**MEETING OF THE
PLANNING AND ZONING BOARD
QUASI-JUDICIAL PUBLIC HEARING**

**TOWN OF BAY HARBOR ISLANDS
PLANNING AND ZONING BOARD**

Subject: Site Development Plan Application
7th Overall Submission / New Design Review #5
Integra Multi-Family Residential – Block 4
10201-10231 E. Bay Harbor Drive
Bay Harbor Islands Acct. No. MB2013-XX
MMPA Acct. No. 01-0702-0971A

Subject: Site Development Plan Application
5th Overall Submission / New Design 4th Submission
Integra Multi-Family Residential – Block 6
10150-10190 E. Bay Harbor Drive
Bay Harbor Islands Acct. No. MB2013-XX
MMPA Acct. No. 01-0702-0971C

A-0.01

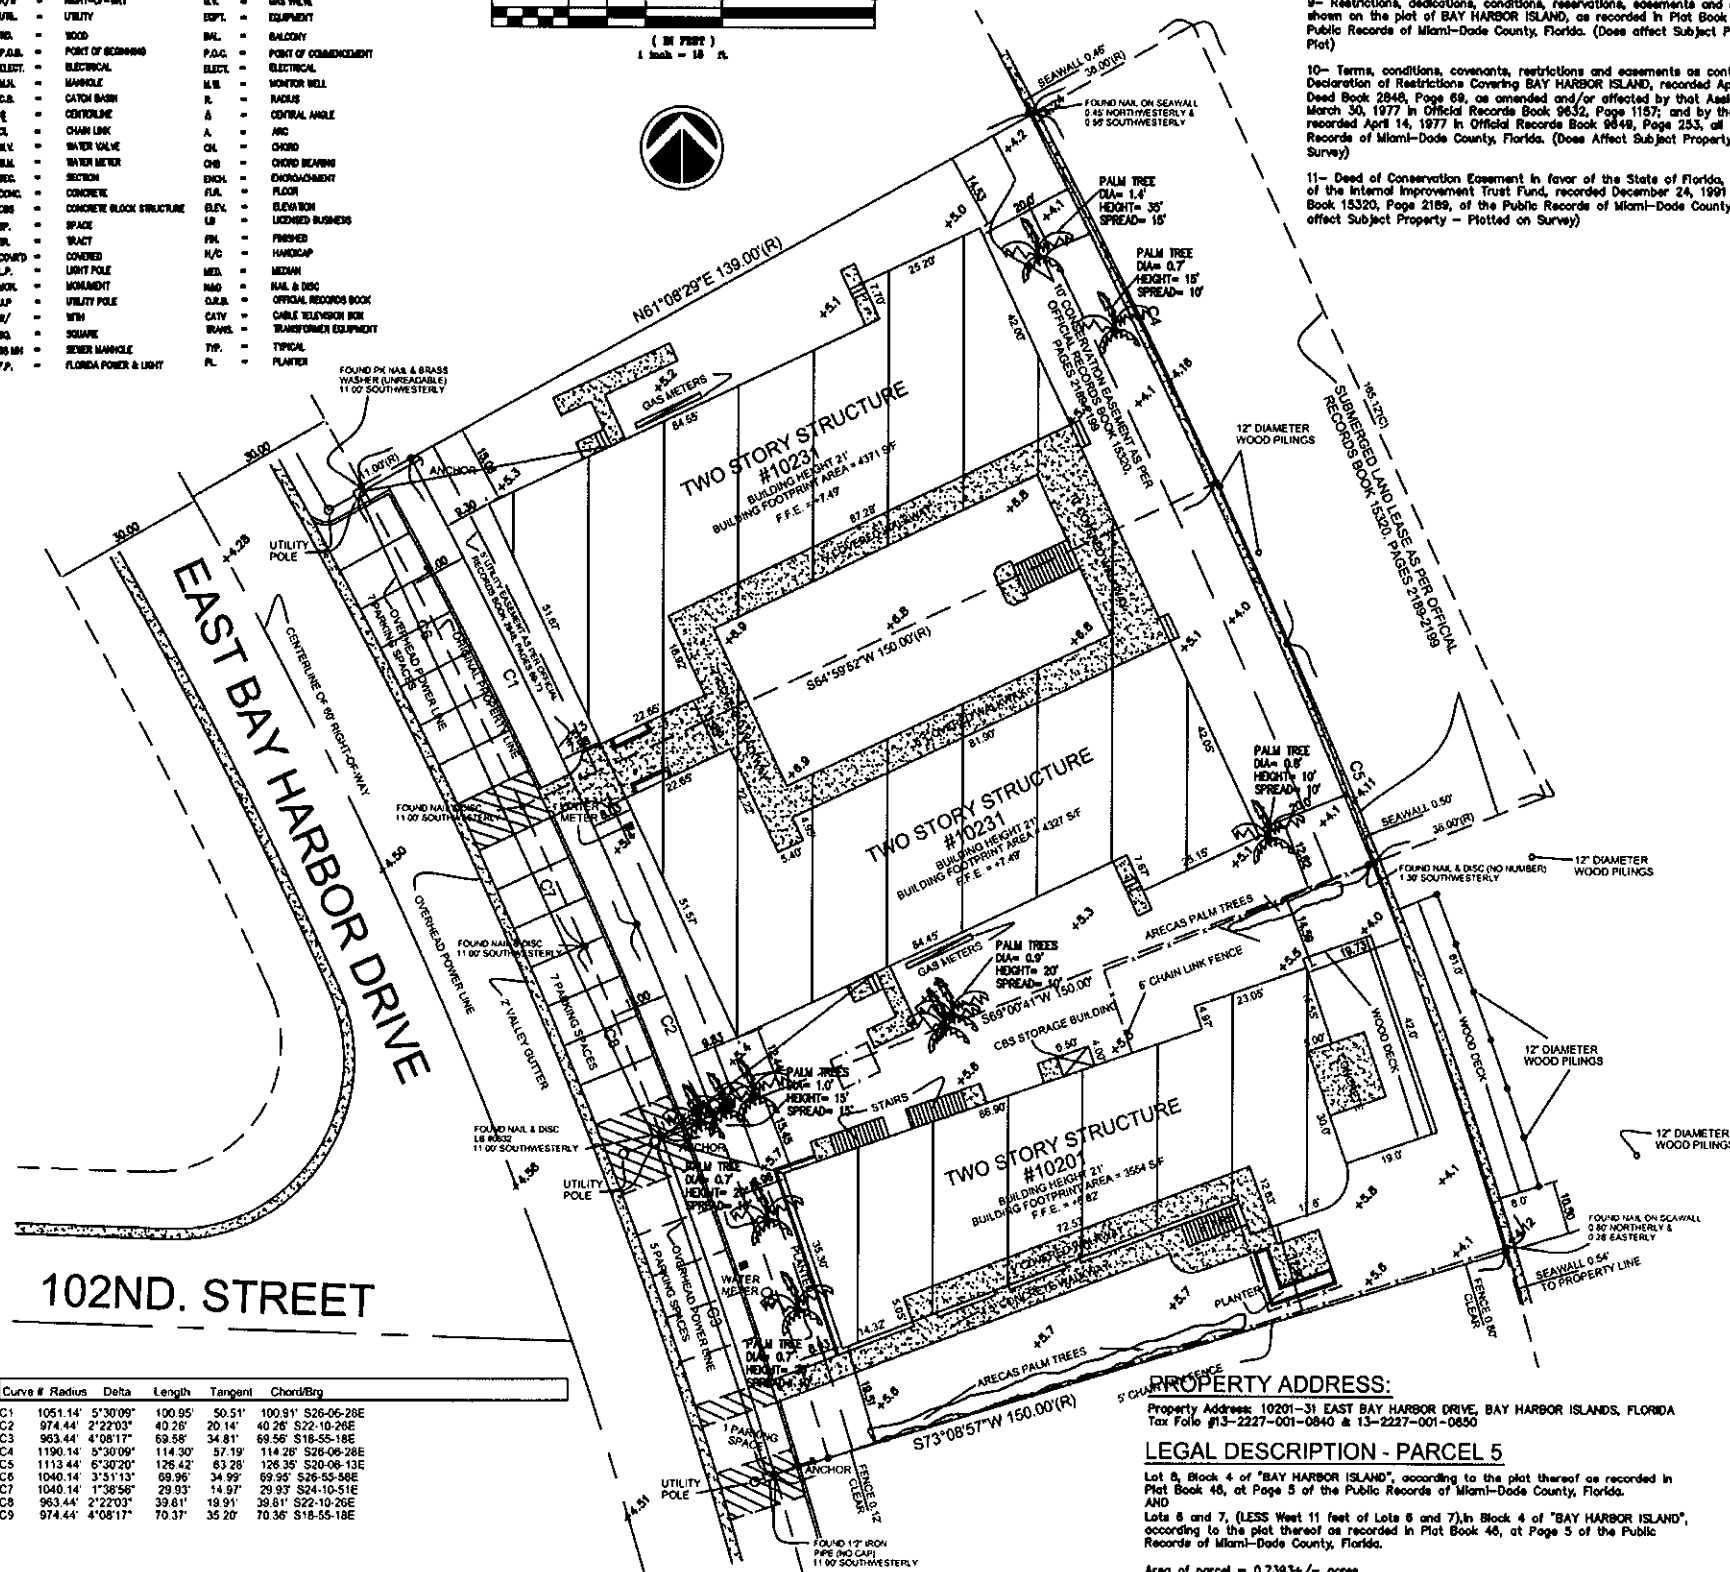
- 4) The Cover Page should have been updated to state "Planning and Zoning Board Submittal" (not DRC Submittal).
- 5) As previously stated, several sheets show a raised patio area in the rear yard area at the east end of the proposed breezeway. As discussed previously the recorded conservation easement appears to prohibit any structure within 20 feet of the seawall. Please provide written approval to the Town staff as to the status of state approval of the current design. A note must be added that the plan is contingent of receiving approval from FIND.
